Application No.	Uses/Developments	Date of Consideration
A/YL-SK/169	Temporary Shop and Services (Horticulture and Interior Design Sample Showroom) and Office for a Period of 3 Years	15.6.2012 [revoked on 15.12.2012]
A/YL-SK/231	Proposed Temporary Public Vehicle Park (Private Car Only) for a Period of 5 Years	6.4.2018 [revoked on 12.3.2020]
A/YL-SK/316	Proposed Temporary Shop and Services (Motor-vehicle Showroom) for a Period of 5 Years	29.10.2021 [revoked on 29.1.2024]

From: [REDACTED]
Sent: 2024-05-19 星期日 03:16:24
To: tpbpd/PLAND <tpbpd@pland.gov.hk>
Subject: A/YL-SK/370 DD 114 To Uk Tsuen, Kam Sheung Road

For Official Use Only 請勿填寫此欄	Application No. 申請編號	A/YL-SK/370
	Date Received 收到日期	19 APR 2024

Gist of Application 申請摘要			
(Please provide details in both English and Chinese <u>as far as possible</u> . This part will be circulated to relevant consultees, uploaded to the Town Planning Board's Website for browsing and free downloading by the public and deposited at the Planning Enquiry Counters of the Planning Department for general information.) (請盡量以英文及中文填寫。此部分將會發送予相關諮詢人士、上載至城市規劃委員會網頁供公眾免費瀏覽及下載及存放於規劃署規劃資料查詢處以供一般參閱。)			
Application No. 申請編號	(For Official Use Only) (請勿填寫此欄)		
L

Figure 2

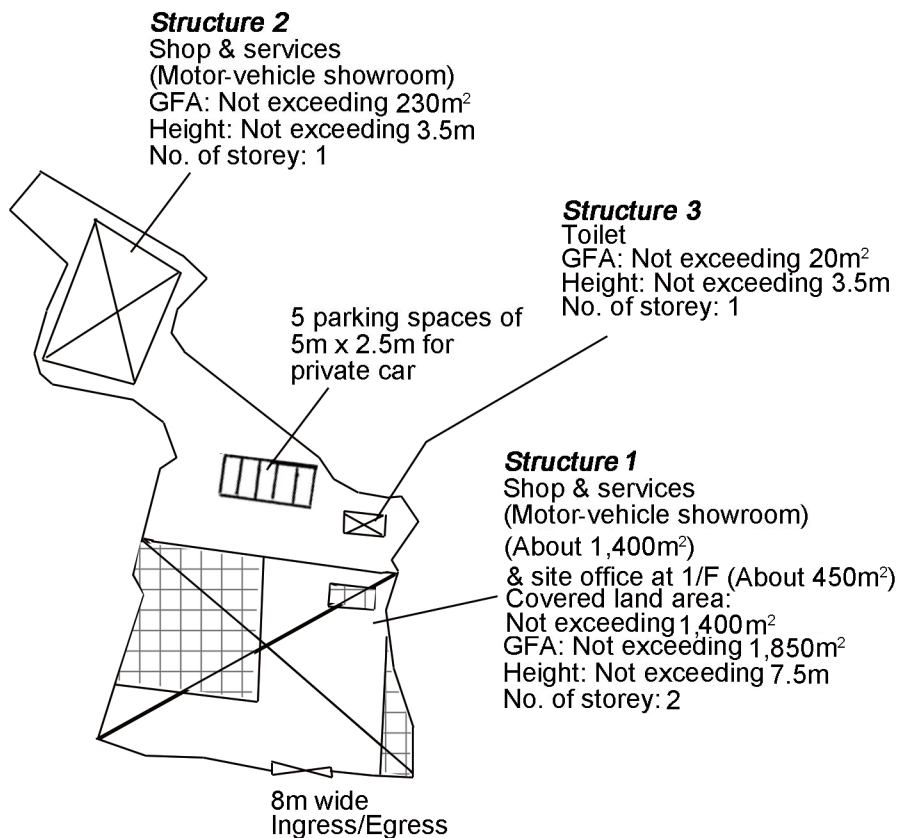
(b) The proposed width of site ingress/egress in the FI (i.e 7m wide on Figure 8) is inconsistent with that indicated on the Figure 2 of the planning application enclosed in your email dated 29 April 2024 (i.e. 8m wide on Figure 2). Please clarify.	The proposed width of the site ingress/egress in Figure 8 has been updated to 8m. Please see attached.
